REVIEW TYPE: Preliminary Plan of Subdivision
APPLYING FOR: Two (2) Single Family Detached Dwelling Unit Lots

PROJECT NAME: Hillmeade – Bradley Hills
CASE NO. 1-03014

Staff Recommendation: Disapproval, Pursuant to Section 50-29(b)(2) of the Montgomery County Subdivision Regulations

PRELIMINARY PLAN

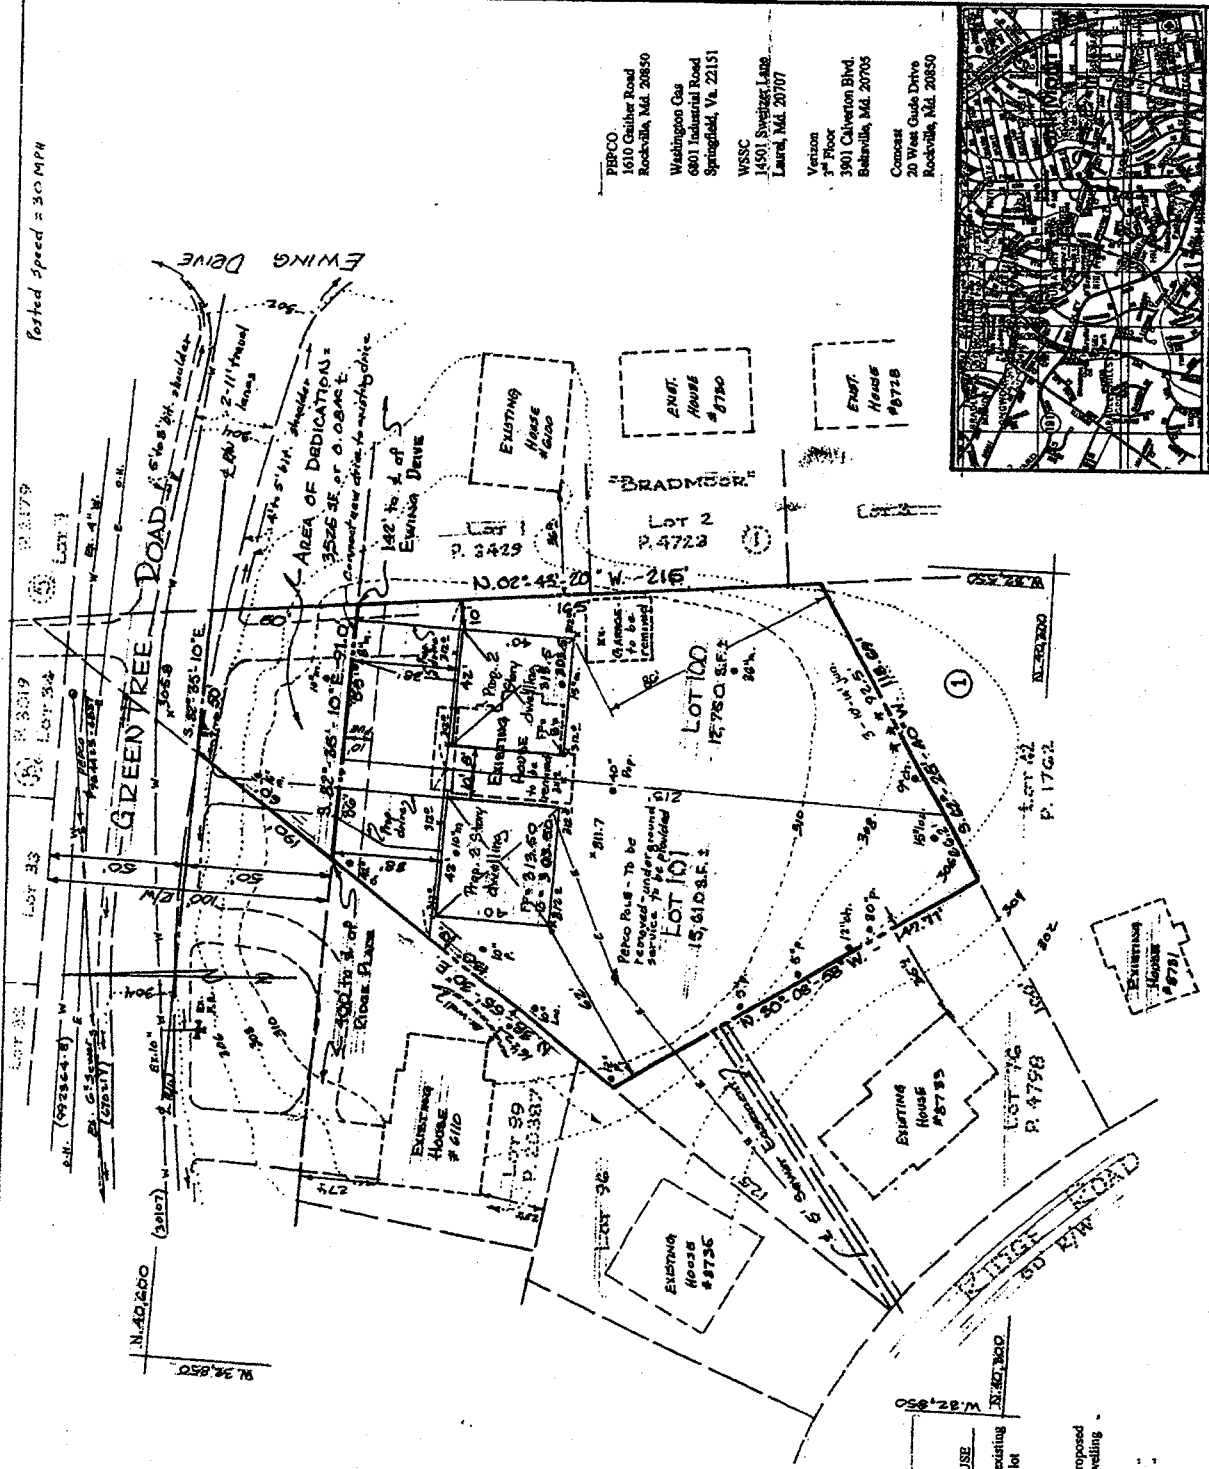
Staff has attached the tabular summary for Planning Board consideration outlining the characteristics under the resubdivision criteria. In reviewing all seven characteristics is evident that the proposed lots are not of the same character as existing lots in the defined neighborhood. The frontage, width and shape are the criteria that staff have concerns with. These characteristics of the proposed lots do not have a high correlation with the other neighborhood lots. **Frontage:** The proposed lots have frontages of 36' and 55'. There are no other lots in the defined neighborhood that have lots with narrower frontages than the proposed lots. The narrowest existing lot in the defined neighborhood is 60 feet. **Width:** The proposed lots each have a width, at the building line of 60 feet. There is only one other lot in the neighborhood that has a narrower width than the subject site. All the other lots in the defined neighborhood have widths in excess of 62 feet, with many being 70 feet or wider. **Shape:** Staff has classified the proposed lots as having an irregular shape. The lots in the defined neighborhood are either square or rectangular. **Alignment** is also a concern to staff. To accommodate the westernmost lot, the western lot line of that lot meets the street at an oblique angle that is out of character with the typical perpendicular alignment. **Area and Size:** The size and area of the proposed lots tend to be larger than the greater majority of lots in the neighborhood. Only one lot, (Lot 42, Block 1) exceeds the size and area dimensions of the proposed lots. **Suitability:** All lots, both proposed and existing, would be deemed suitable for residential development.

In applying the resubdivision criteria to the analysis area delineated by staff, staff concludes that the proposed resubdivision does not satisfy the resubdivision criteria set forth in Section 50-29(b)(2) as illustrated by the characteristics illustrated in the attached tabular summary. The proposal does not reflect a high correlation with all seven characteristics. Specifically, the application proposes two (2) lots that are not of the same dimensional character with respect to frontage and width with respect to the lots in the defined neighborhood. Furthermore, the proposed lots have shapes, alignments, sizes and areas that are not consistent with the majority of lots within the defined neighborhood. In conclusion staff does not support the preliminary plan application for two (2) lots based on the provisions found in 50-29(b)(2).
